GEORGIA DEPARTMENT OF TRANSPORTATION

Widening SR 42/US 23 from SR 138/Henry to I-675/Clayton

STP00-0037-02(056) – P.I. No. 322050-

VALUE ENGINEERING REPORT

ALTERNATIVE NO.:
RD-1

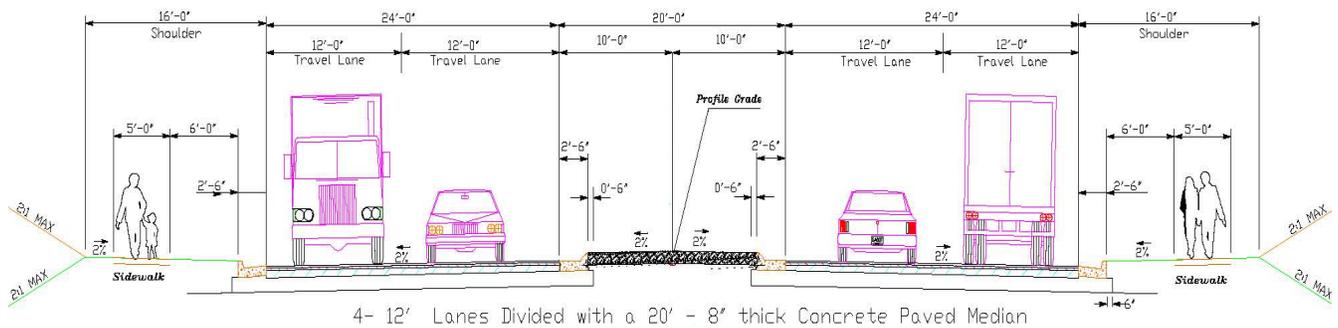
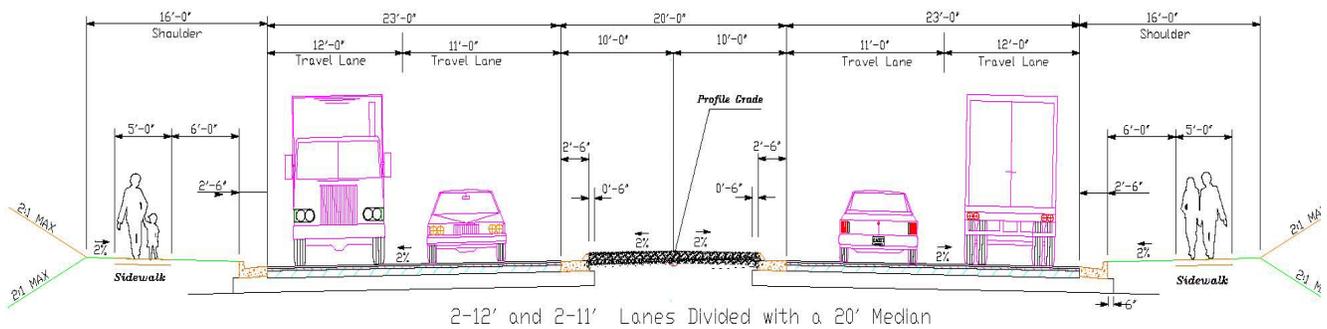
The original design proposes construction of two 12’ travel lanes eastbound and westbound throughout the project.

The alternative proposes constructing a 12’ outside travel lane, as well as an 11’ inside travel lane throughout the project.

Reduction of width of travel lanes throughout the project would result in 2’ of full build-up widening that would not have to be constructed, resulting in significant cost savings. AASHTO’s “Policy on Geometric Design of Highways 2004” states that 11’ lanes are permissible. It also states that under interrupted –flow operating conditions at low speeds (45 mph or less), narrower lanes are normally adequate and have some advantages. (See Pages 472-473). The combination would construct 12’ outside lanes to accommodate the local truck traffic, as well as allowing a greater turn radius to right-turning vehicles.

ALTERNATIVE NO.:
RD-3

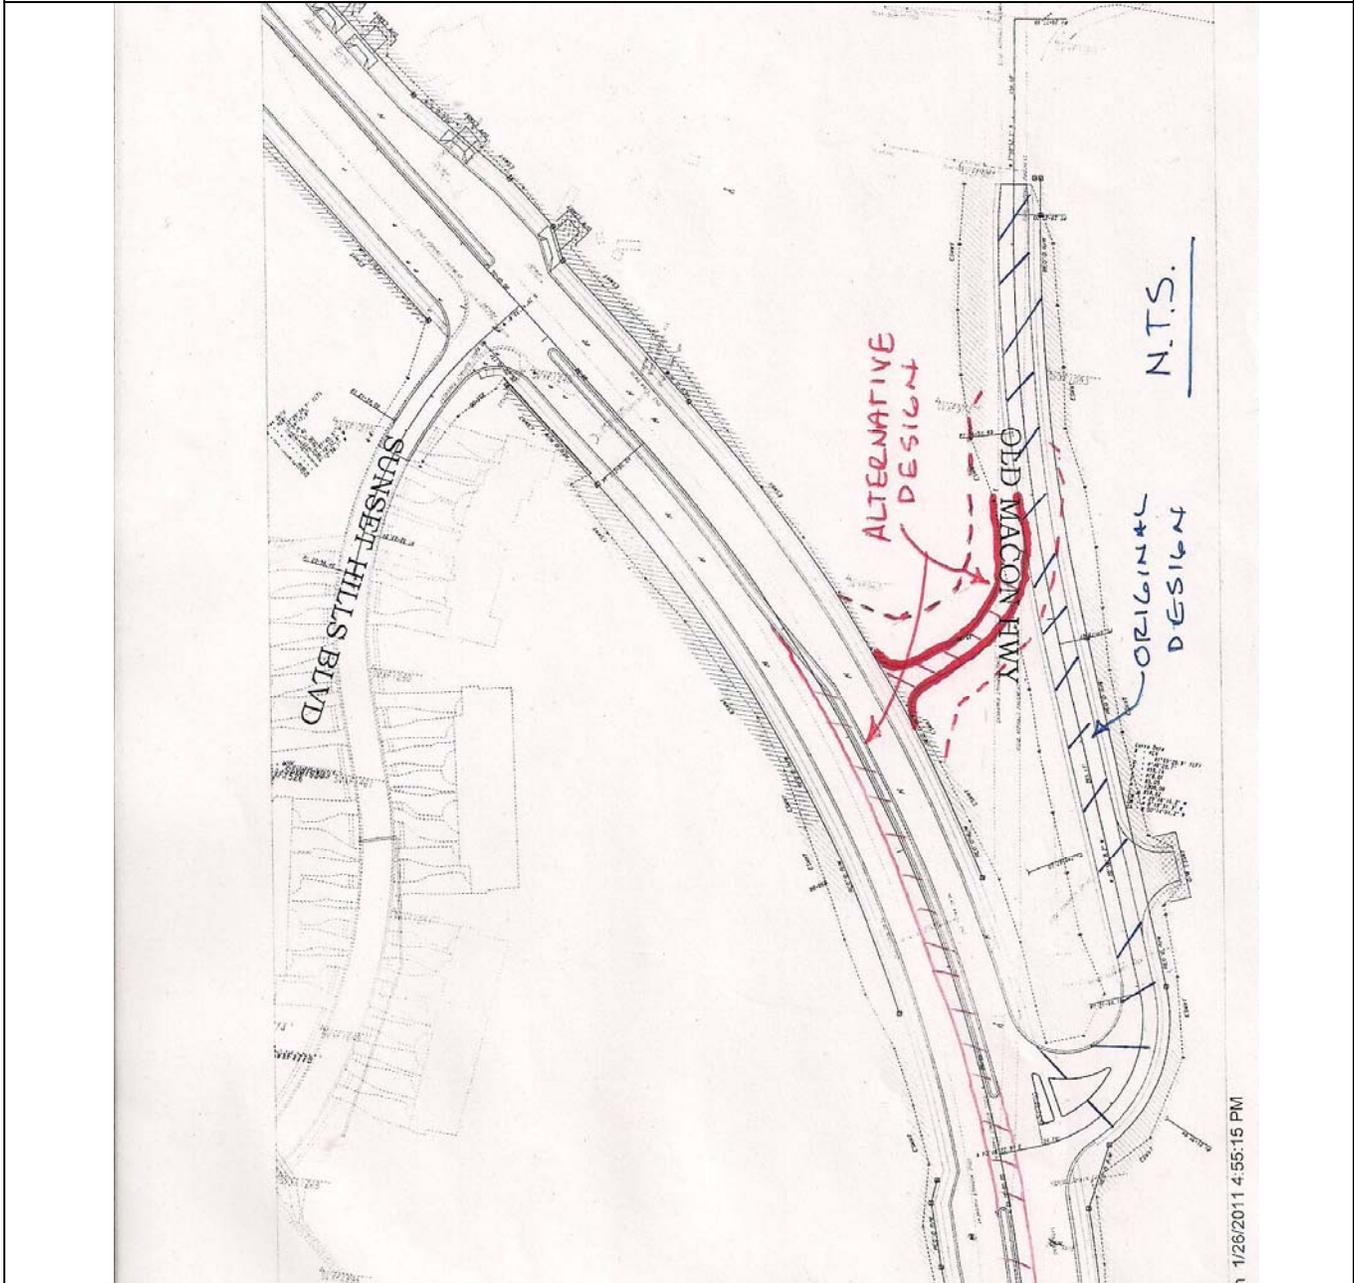
The original design proposes reconstructing/relocating approximately 850 feet of Old Macon Highway. The original design also introduces a new horizontal vertical curve to create a 90° intersection at Station ~246+46.

The alternative design proposes reconstructing a shorter section of Old Macon Highway and utilizing a larger radius horizontal to create a 90° “right in – right out” intersection at Station ~ 252+00.

Old Macon Highway between SR-42 and the neighborhood to northeast of the project along Homestead Road is sparsely developed. Most of the traffic generated at this intersection is due to ingress and egress to the neighborhood and not from adjacent development. The project will provide access between the neighborhood and SR-42 via Crooked Creek Road, Breckenridge Run and Edward Road with numerous interconnects for “backstreet circulation”.

ALTERNATIVE NO.:
RD-7

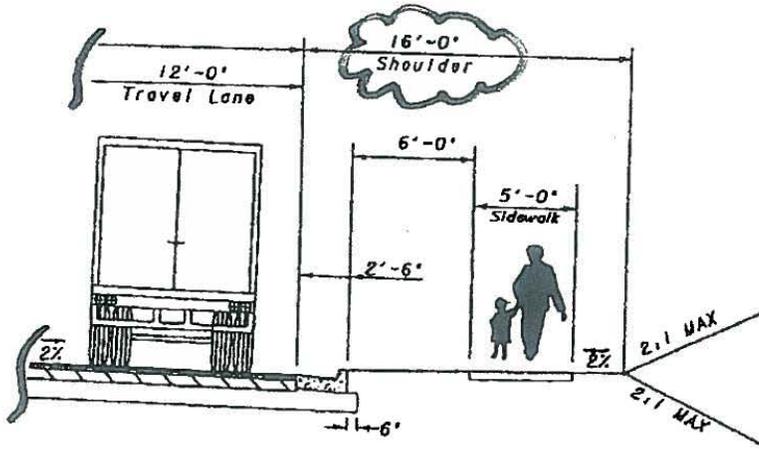
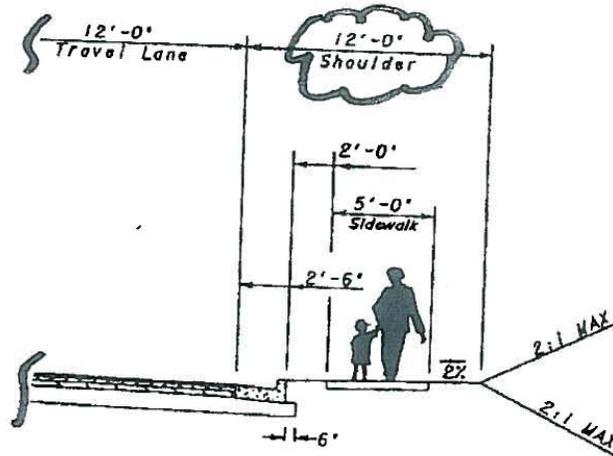
The original design calls for the construction of 16' shoulders in either direction throughout the project

The alternative proposes constructing 12' shoulders in either direction throughout the project

The alternative proposes constructing 12' shoulders in both directions of the proposed roadway, in lieu of the as-designed 16' shoulders. The alternative will have the effect of reducing 4' of ROW required in each direction by narrowing the shoulders. All of the proposed design elements will remain on the alternative shoulders (i.e. 5' sidewalk). Identified risks include a possible reduction in width for staging during construction, which would need to be developed as the project plans progress. It may also be possible to utilize a 12' shoulder on one side, while constructing a full 16' urban shoulder on the other side if the relocation and placement of utilities would make uniform 12' shoulders undesirable throughout the project. The ROW savings using a 16'/12' shoulder would be half the figure shown in this alternative. It is noted that the Preliminary Right of Way Estimate dated 1/25/2008 provided to the VE Team in the concept report contained a total of 62 parcels and includes no temporary or permanent easement costs. The PM has advised that the parcel count is now 82 for the project. Therefore, the ROW costs will vary from the estimate provided to the team. The 8' width reduction cost savings are shown as proportional to the costs and quantities provided to the VE Team by the design consultant. See calculations page for more detail.

CURRENT DESIGN: GA STD 4948-B

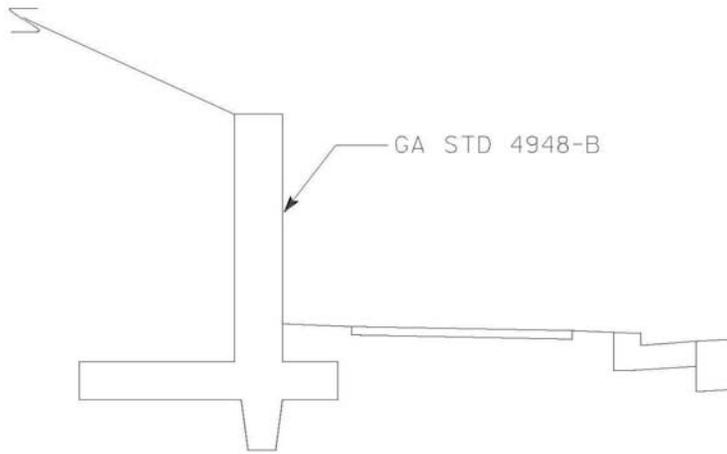
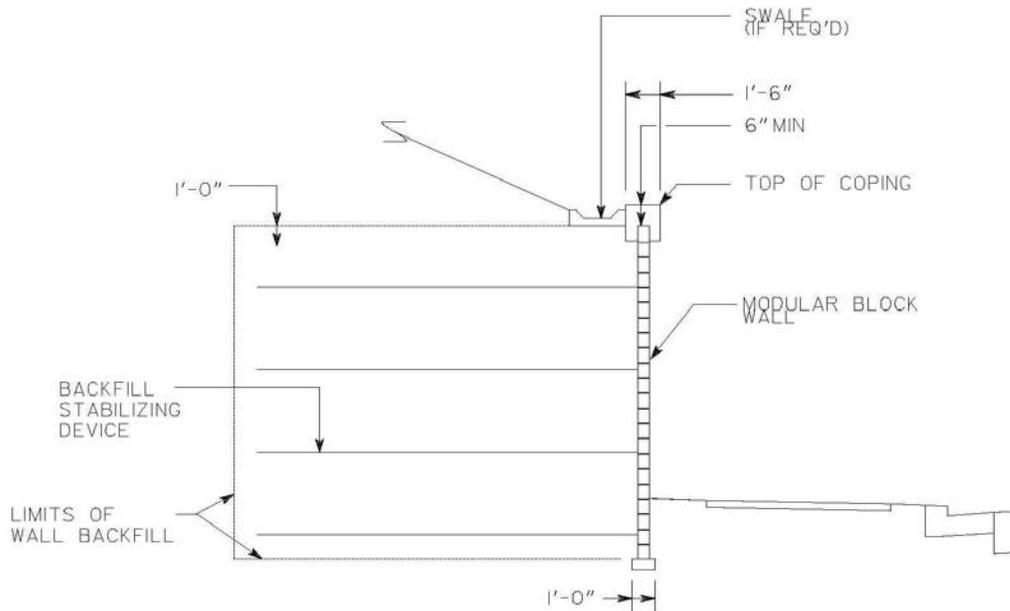
The original design calls for stretches of walls along the project at 10 locations. The walls are poured in place GA STD Retaining Walls. Walls heights vary from an average of 7 feet to an average of 10 feet.

The alternative proposes the use of Modular Block walls in-lieu of the cast-in-place concrete retaining walls. The alternative maintains the original design geometry.

Modular Block walls have demonstrated acceptable performance and longevity. Performance warranties are also provided by the manufacturers.

ALTERNATIVE NO.:
RD-12

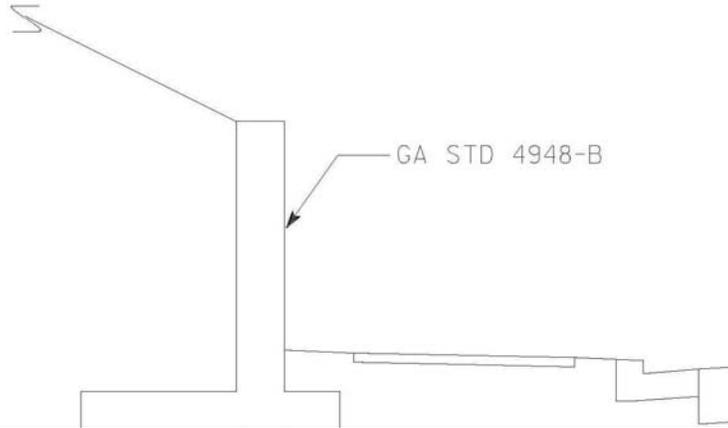
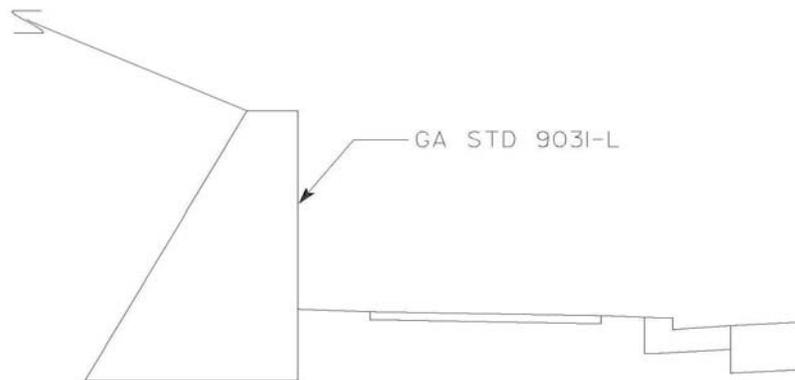
The original design calls for stretches of walls along the project at 10 locations. The walls are poured in place GA STD Retaining Walls. Walls heights vary from an average of 7 feet to an average of 10 feet.

The alternative proposes the use of GA STD 9031-L Gravity Retaining Walls in-lieu of GA STD 4948-B cast-in-place concrete retaining walls. The alternative maintains the original design geometry.

Gravity Retaining walls are commonly used where wall heights are below 10 feet. Their performance and longevity on case-studies has been satisfactory.

ALTERNATIVE NO.:
RD-15

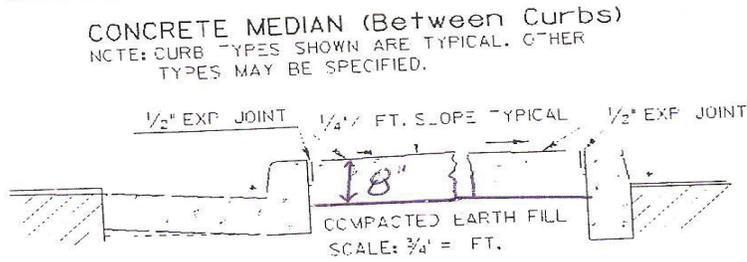
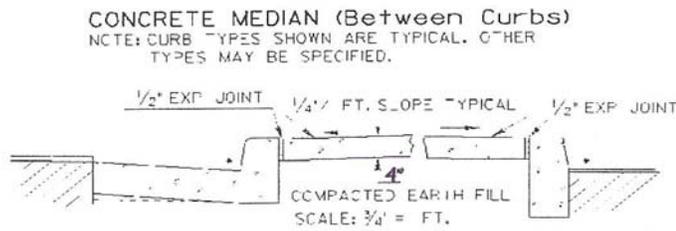
The original design calls for the construction of a 7.5” concrete median as the surface for the 20’ proposed raised median.

The alternative proposes using a 4” concrete median as the surface for the proposed 20’ raised median.

The alternative proposal would reduce the proposed thickness of the 20’ concrete median from 7.5” original to 4” proposed. The resulting cost savings are based on the differential in unit prices of the above items. Additional costs may be incurred in providing fill to account for the vertical difference between the 7.5” proposed surface and the 4” alternative treatment.

PROJECT:	Georgia Department of Transportation STP00-0037-02(056) – P.I. No. 322050- Widening SR 42/US23 from SR 138 to I-675 Clayton/Henry Counties	ALTERNATIVE NO.: RD-16
DESCRIPTION:	Remove and replace existing pavement to eliminate leveling in select areas	SHEET NO.: 2 of 4

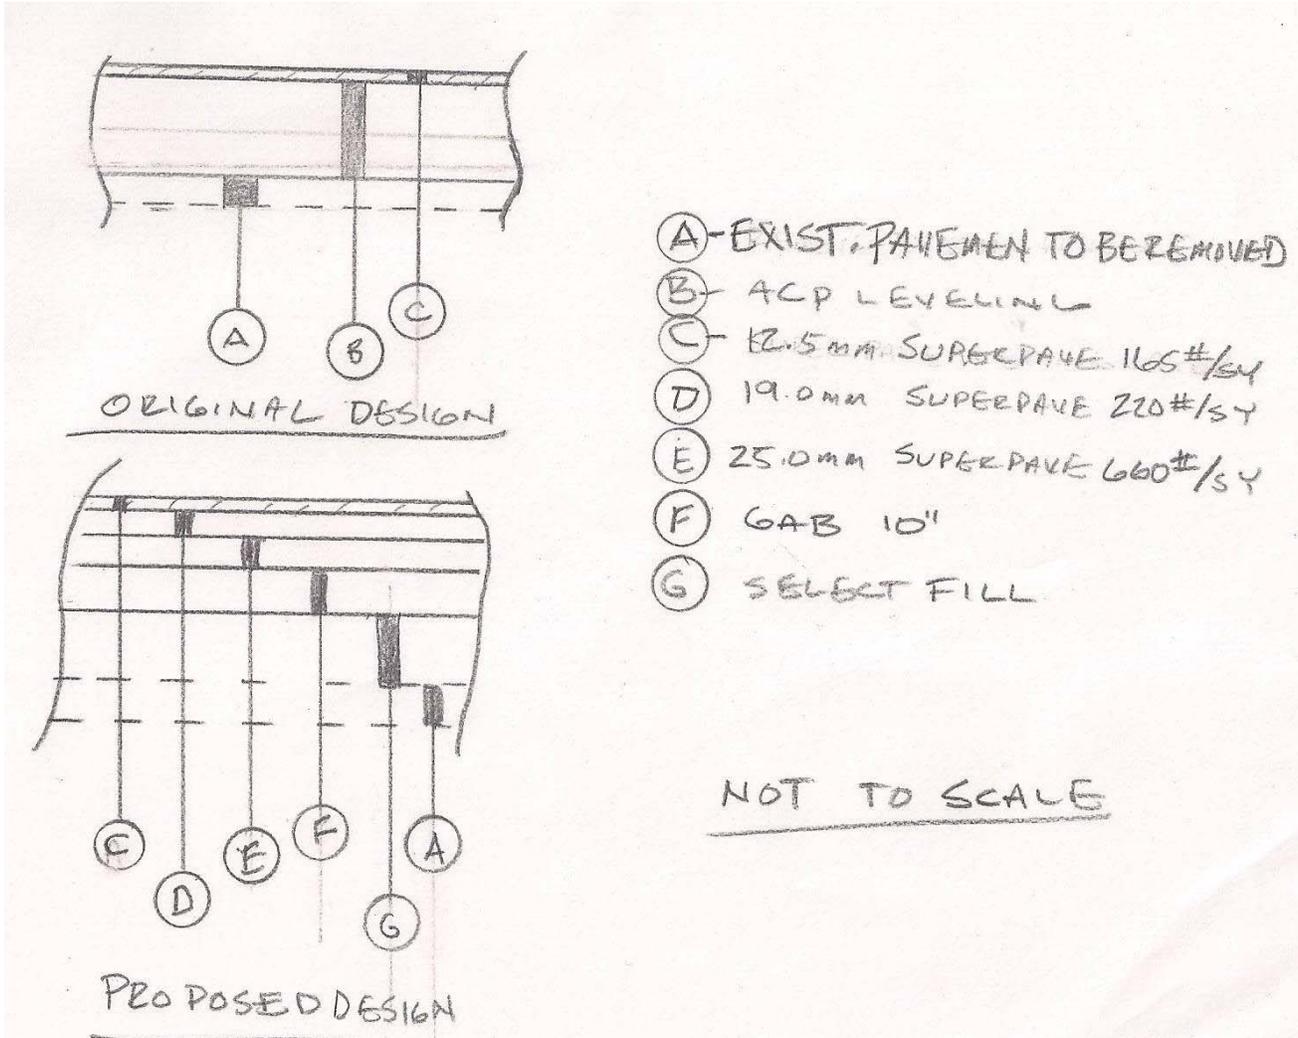
The original design proposes leaving the existing roadway in place and overlaying with a leveling layer up to 4.0 feet thick.

The alternative design proposes removing the existing pavement and constructing a new pavement structure in selected areas.

Portions of the proposed roadway are to have leveling that is up to 4.0 feet thick. Placing ACP leveling that thick in addition to being extremely expensive would most likely not be able to be done under traffic. The typical pavement structure could be constructed and the existing pavement removed. Removing the pavement in the areas where there is PGL is 1.625' to 4.00' higher would eliminate placing a small layer of fill between two layers of asphalt paving. The removed pavement could also be use as fill on other portions of the job.
